LICENSEE: Union Electric Company
FACILITY: Callaway Plant, Unit 1
SUBJECT: MINUTES OF MEETING WITH UNION ELECTRIC REGARDING PROPOSED
MODIFICATIONS TO THE LOW TEMPERATURE OVERPRESSURE PROTECTION
(LTOP) SYSTEM AT CALLAWAY

PROPOSED MODIFICATIONS TO THE LTOP

SYSTEM AT CALLAWAY

New Proposed Design

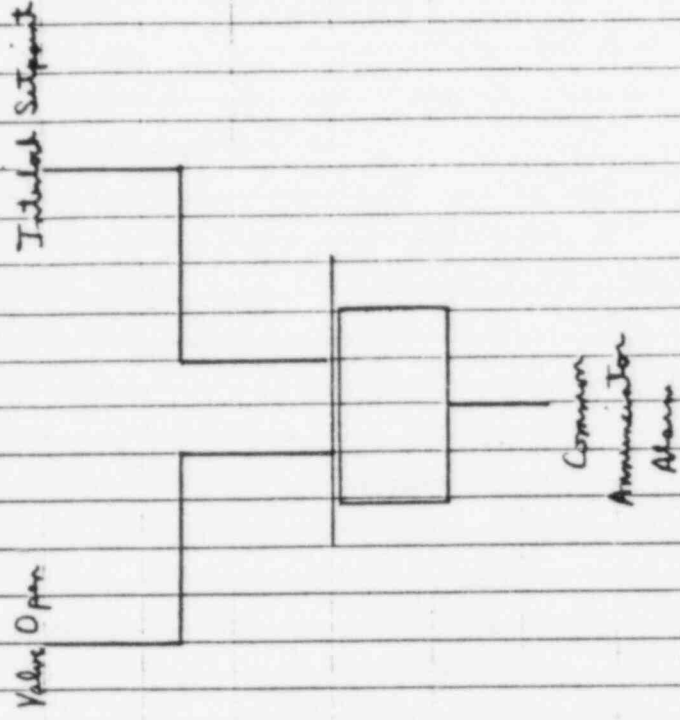
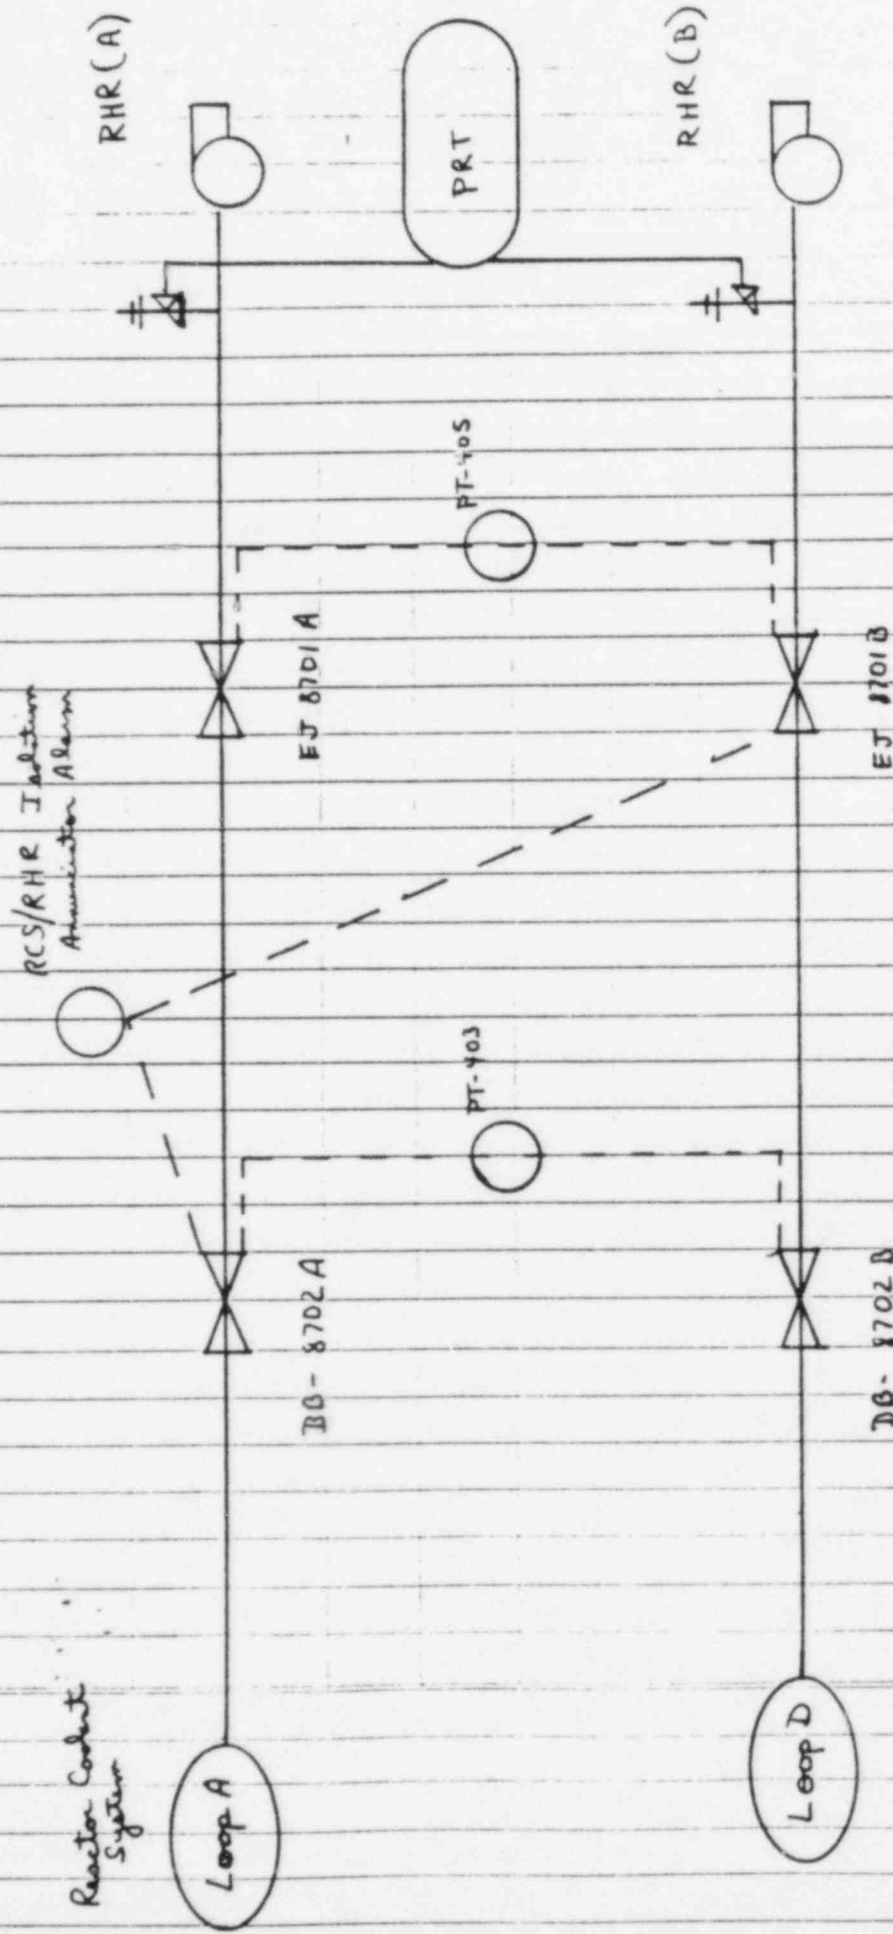
The licensee informed the staff that they have identified a problem with implementing the alarm circuitry as described in their December 28, 1984 submittal. That submittal describes the addition of an alarm circuit to certain RHR/RCS suction isolation valves such that if the valves are open or do not have power available and the interlock activation setpoint is reached, the alarm would initiate on the main control board. This ensures that the valves are closed as pressure increases past the interlock activation setpoint. The problem arises at higher power and pressure levels when power to the valves is locked out to prevent inadvertent or spurious opening of the valves. At this point, the "no power" input to the alarm circuitry activates the alarm. Although the audible portion of the alarm can be cleared, the light on the control board will remain.

The licensee is now considering a new proposal to satisfy LTOP concerns. The new proposal would have an alarm circuit that would initiate only if the valves are open and the interlock activation setpoint is reached. In addition, valve status will be obtained directly from the valve instead of from the motor control center as in the original proposal.

The staff stated that the new proposal appears to be acceptable at their review level, however they cautioned that the ultimate decision rests with their management. The licensee stated that they did not expect to obtain staff approval at this time. Rather, they were interested in any feedback the staff had to offer so that any staff concerns would be addressed in their formal submittal, currently expected in about 1 week. The licensee desires to have staff approval of their new proposal by the end of this year so they can begin implementing the modifications at their first refueling outage, currently scheduled to begin on March 1, 1986.
